STAFF RECOMMENDATION
402-B North 17th Street
April 18, 2018

Application: New construction – infill
District: Lockeland Springs-East End Neighborhood Conservation Zoning Overlay
Council District: 06
Map and Parcel Number: 08310047200
Applicant: Brad Sayers, Four Square Design Studio, LLC.
Project Lead: Melissa Sajid, melissa.sajid@nashville.gov

Description of Project: Application is to construct one-and-a-half story infill on a vacant lot.

Figure 1: Vacant lot at 402-B North 17th Street

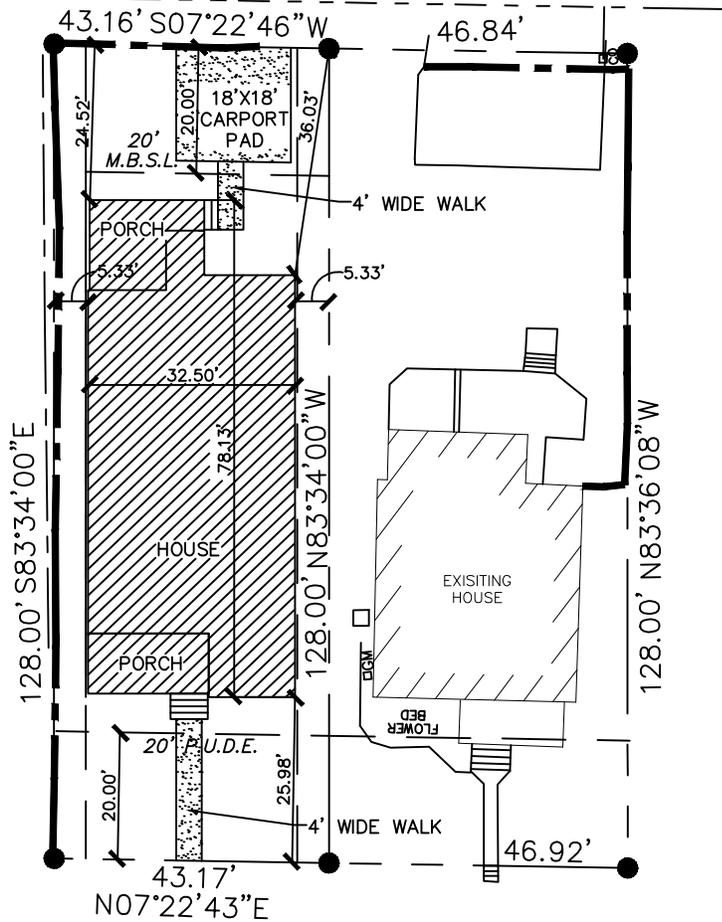
Background: The property located at 402-B North 17th Street is a vacant lot (Figure 1). At approximately forty-three feet (43') wide, the lot is somewhat narrower than most lots on this block of North 17th Street.

PRELIMINARY PLOT PLAN

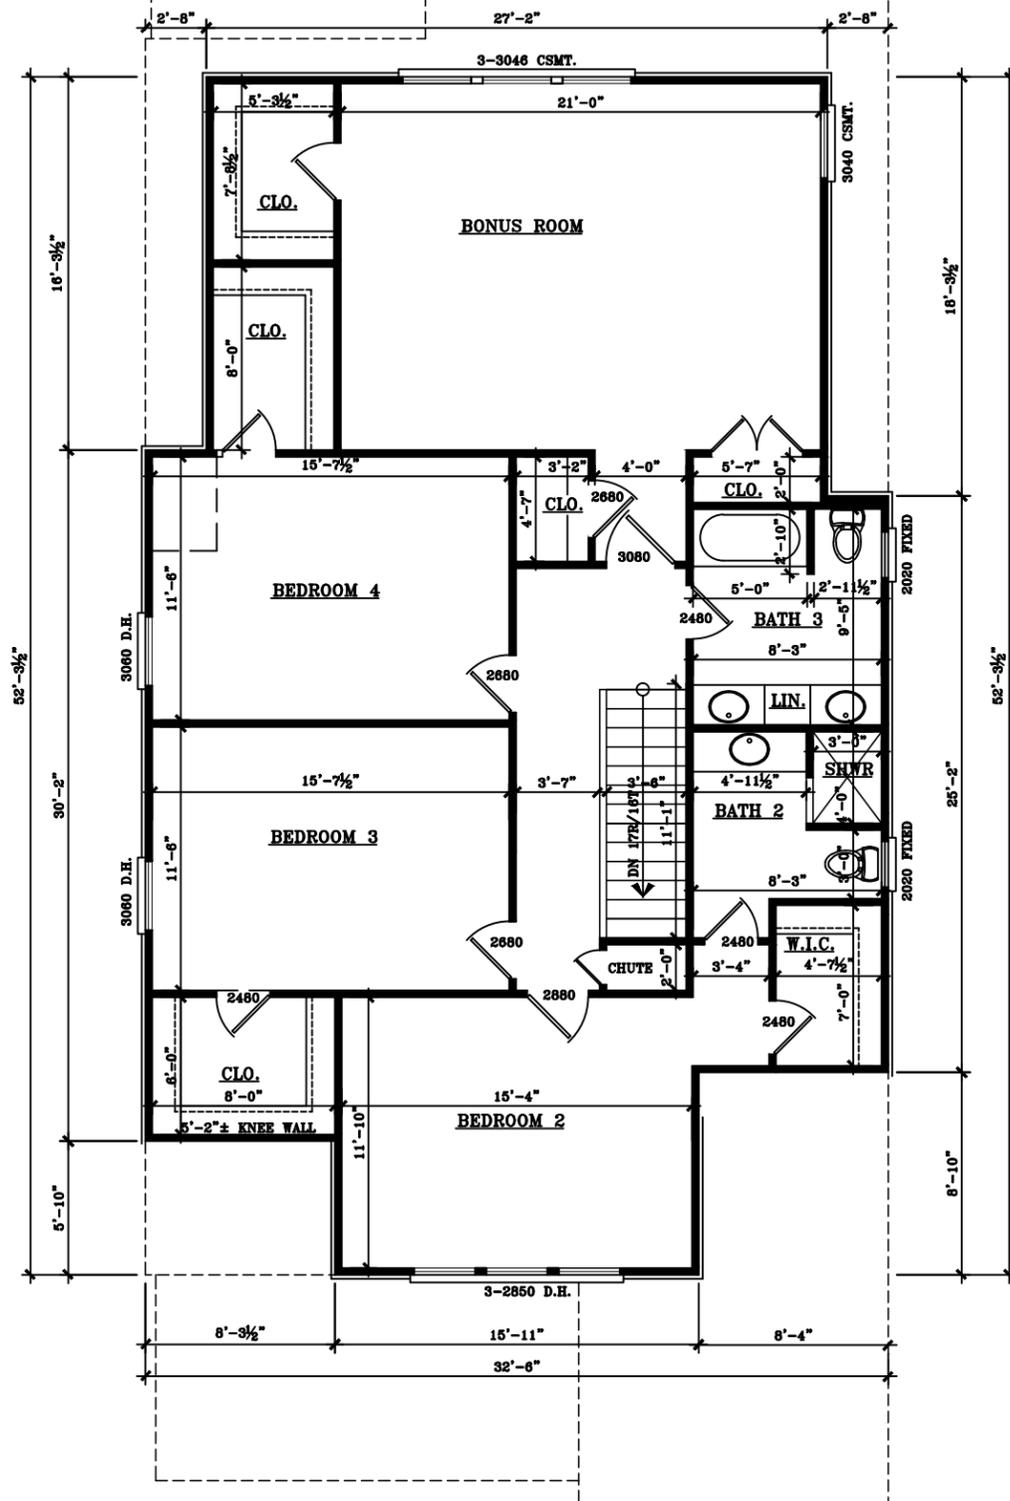
Setback & Rhythm of Spacing: The proposed infill meets all base zoning setbacks. It will be five feet, four inches (5'-4") from each of the side property lines, and twenty-four feet (24') from the rear property line. Its front façade will be twenty-six feet (26') back from the property line, similar to the front setback for the historic house next door at 402 North 17th Street.

Orientation: The infill is oriented towards North 17th Street with parking off the alley at the rear. The site plan indicated a carport pad at the rear of the property; however, plans for a carport (outbuilding) are not part of this application. The applicant has been advised that the depth of the infill may pose issues for an outbuilding in the future since the separation shown is approximately only six feet (6') and the Commission typically requires twenty feet (20') or ten feet (10') for shallow lots. In addition, the plans show a zero foot (0') rear setback for the carport; since the carport would be accessed from the alley the minimum rear setback would be ten feet (10') although the Commission has approved five feet (5') for shallow lots. The infill includes a partial width front porch that is approximately nine feet (9') deep, which meets the design guidelines. The project meets section II.B.6.

ROOF SCHEMATIC
SCALE: 1/16" = 1'-0"

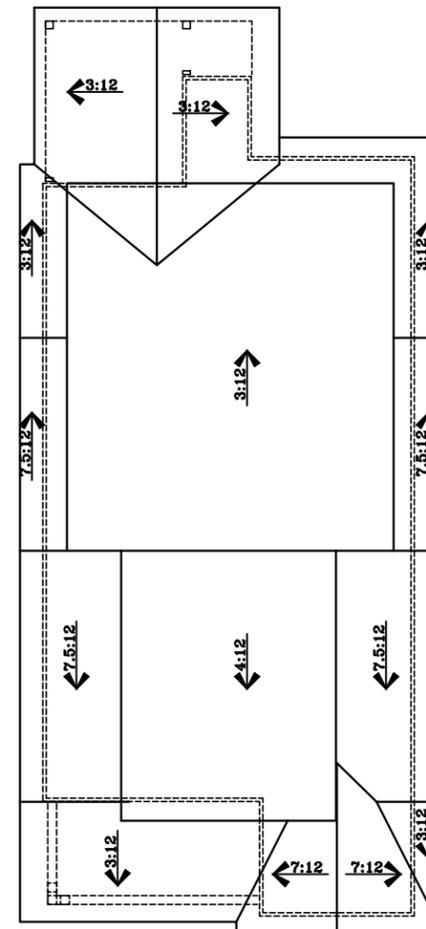
Roof form: The primary roof form is cross gable with pitches of 7/12 and 7.5/12. Shed dormers are proposed at the front and rear of the house and have pitches of 4/12 and 3/12, respectively. The porch roof ties into the front gable and has a pitch of 3/12. Staff finds that the proposed roof forms are similar to roof forms found on other historic houses in the conservation overlay. Staff therefore finds that the infill's roof forms meet Section II.B.5. of the design guidelines.

RIGHT ELEVATION
SCALE: 1/8" = 1'-0"

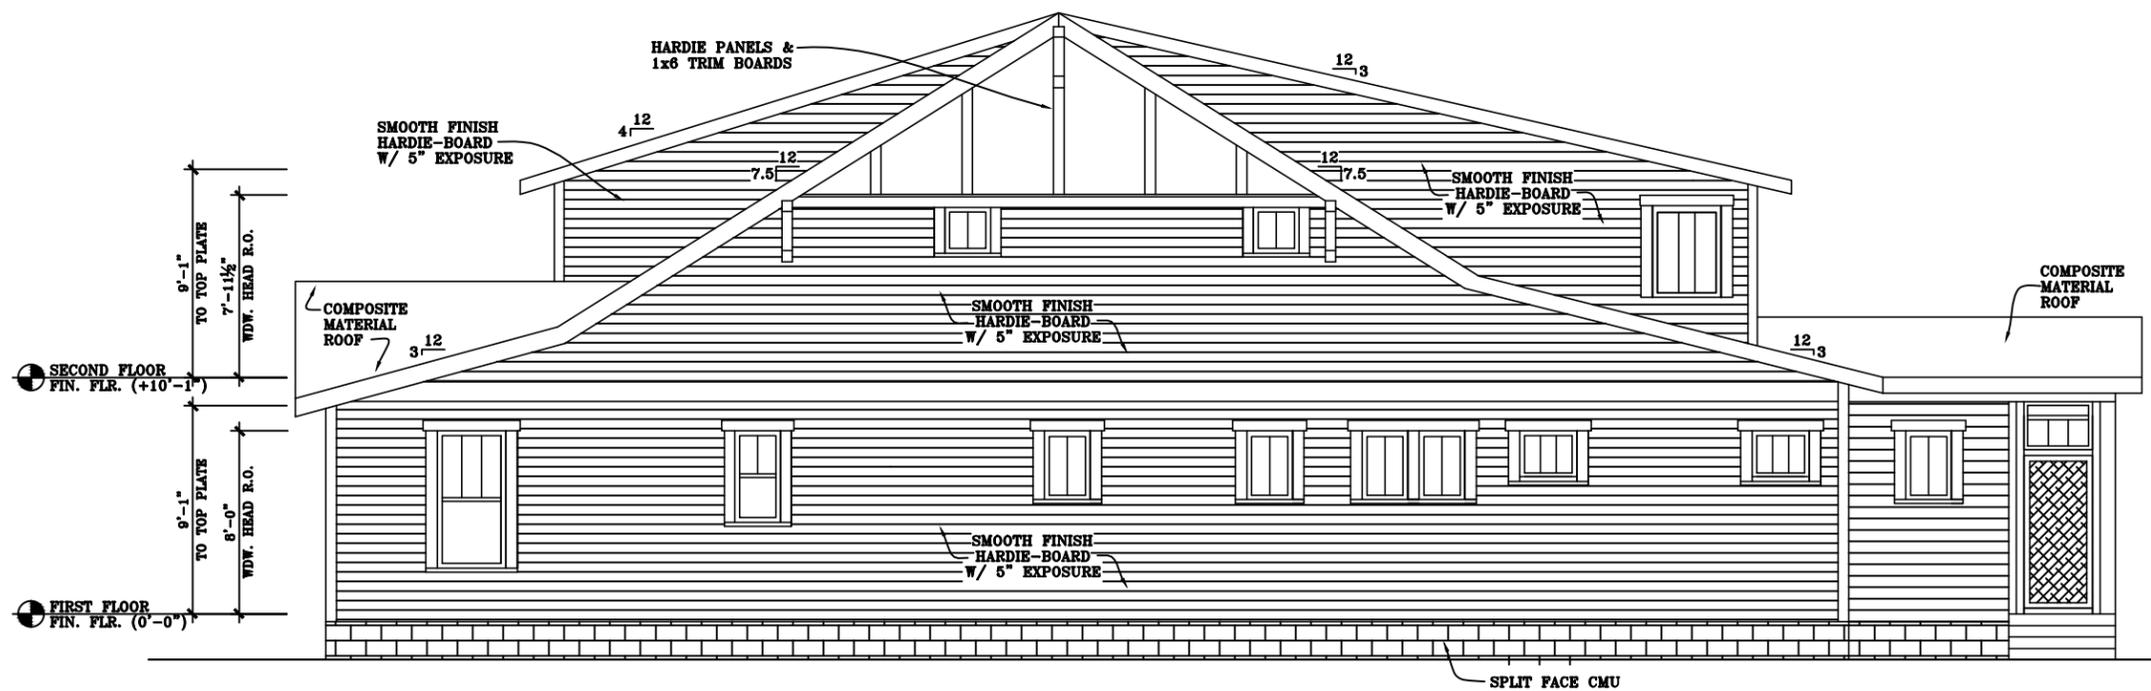
Proportion and Rhythm of Openings: Not all of the windows on the infill are generally twice as tall as they are wide, which is typical of the historic proportions of openings. While some smaller, square window openings may be appropriate on the sides near the rear or on the rear of the infill, staff finds that the infill incorporates too many smaller, square windows where they are likely to be visible. The right side façade incorporates a number of smaller, square windows including those proposed near the gable field. Staff recommends that the window openings on the right side façade be revised to meet Section II.B.7. of the design guidelines. There are no large expanses of wall space without a window or door opening. With the condition that the proportion of openings on the right side façade be revised to meet Section II.B.7, staff finds the project's proportion and rhythm of openings can meet Section II.B.7.

3. The proportion of openings on the right side façade be revised to meet Section II.B.7.;
and
4. The HVAC be located behind the house or on either side, beyond the mid-point of the house.
